PCN # 252
Notification Date:
March 8, 2024

Product / Process Change Notice

Devices affected:
The CBRDFSH2-100 Schottky bridge rectifier manufactured in the BR DFN case.

Table 1:

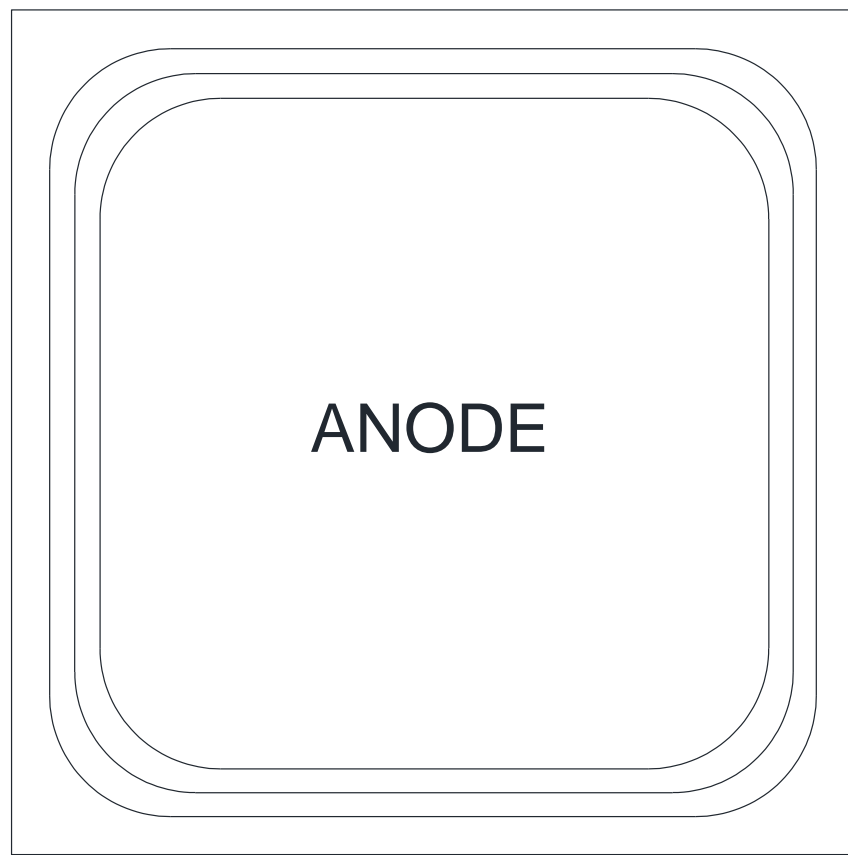
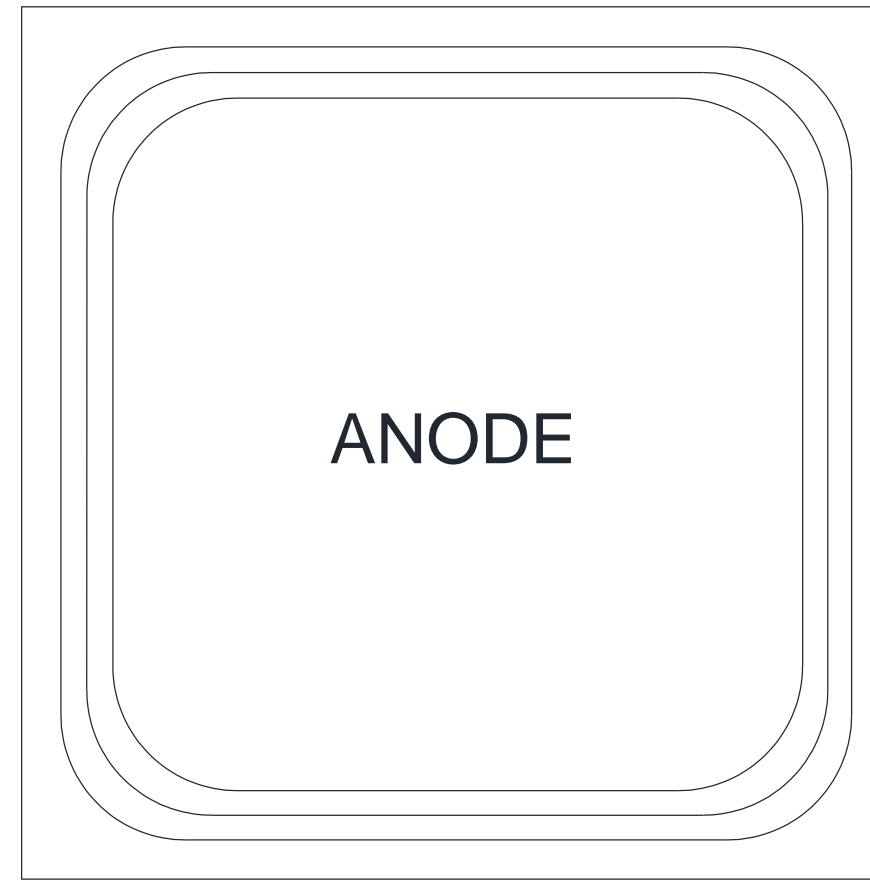
Extent of change:
Change in wafer fab, resulting in change in die size from 45 x 45 mils to 46 x 46 mils (see Table 1).

Die Size	45 x 45 MILS
Die Thickness	10 MILS
Anode Bonding Pad Size	40 x 40 MILS
Top Side Metalization	Ti/Ni/Ag
Back Side Metalization	Ti/Ni/Ag

Die Size	46 x 46 MILS
Die Thickness	11.8 MILS
Anode Bonding Pad Size	41.8 X 41.8 MILS
Top Side Metalization	TiW/TiNi/Ag
Back Side Metalization	Ti/Ni/Ag
